Access Compliance Report

Public Rights-of-Way

(Curb Ramps)

Intersection ID: 18701	Main Street: PROVIDENCE_RD	Cross Street: RUTLEDGE_AV	Location: W
ADA ID: F6FF48A90823	Ramp Type: BlendTrans1	Initial Pass/Fail: Fail	Overall Compliance: No
Severity Score: 12.5			
Codes/Mitigation Info/Possible Solution		Field Measurements/Component Compliance

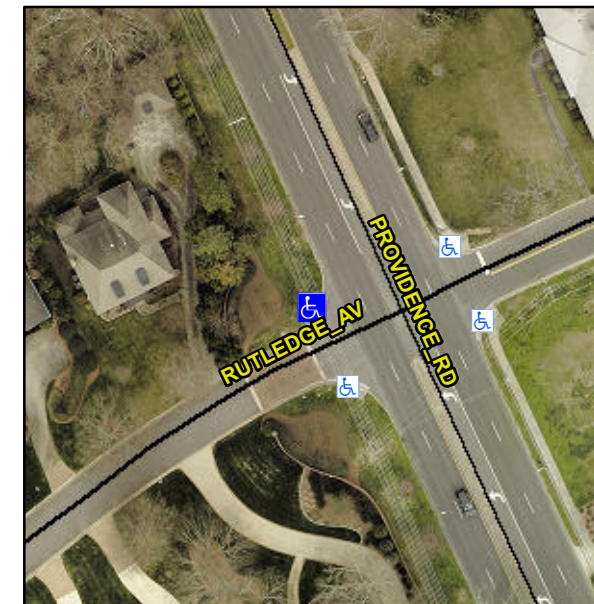
Not Found, R304.5.3

Compliance	Description	Data	Compliance	Description	Data
N/A	Ramp Length (in)	25.0	Yes	BlendTrans Slope (%)	4.5
Yes	Ramp Width (in)	48.0	No	BlendTrans XSlope (%)	6.5
N/A	Flare Type LT	N/A	N/A	Flare Type RT	N/A
N/A	Flare Slope LT (%)	N/A	N/A	Flare Slope RT (%)	N/A
N/A	Flare Traversable LT?	N/A	N/A	Flare Traversable RT?	N/A
N/A	Landing Length (in)	N/A	N/A	DWS Provided?	N/A
N/A	Landing Width (in)	N/A	N/A	DWS Contrast?	N/A
N/A	Landing Slope (%)	N/A	N/A	DWS Length (in)	N/A
N/A	Landing X Slope (%)	N/A	N/A	DWS Full Width?	N/A
N/A	Landing Curb? (Y/N)	N/A	N/A	DWS Offset (in)	N/A
N/A	Shared Landing?	N/A			
N/A	Gutter Ponding?	N/A	N/A	Gutter Slope (%)	N/A
N/A	Gutter Lip Ht (in)	N/A	N/A	Gutter X Slope (%)	N/A
N/A	Painted X Walk1?	No	N/A	Painted X Walk2?	No
	X Walk 1 Direction	To S		X Walk 2 Direction	To E
	X Walk 1 Width (in)	N/A		X Walk 2 Width (in)	N/A
	X Walk 1 Slope (%)	1.8		X Walk 2 Slope (%)	N/A
	X Walk 1 X Slope (%)	7.7		X Walk 2 X Slope (%)	N/A

N/A	Ramp inside XWalk1?	N/A	N/A	Ramp inside XWalk2?	N/A
	Road Slope (%)	7.7		Clear Space?	N/A
	Road X Slope (%)	1.8	N/A	Clear Space to XWalk (in)	N/A
N/A	Any Obstructions?	N/A	N/A	Storm Grate/Utility Hazard?	N/A
	Obstruction Type			Storm Grate/Utility Type	
		N/A			N/A
			Yes	Surface Condition? (G/P)	Good
			No	Curb Slope (%)	8.9

Remove & Replace Curb Ramp With Two New Directional Ramps or Equivalent.
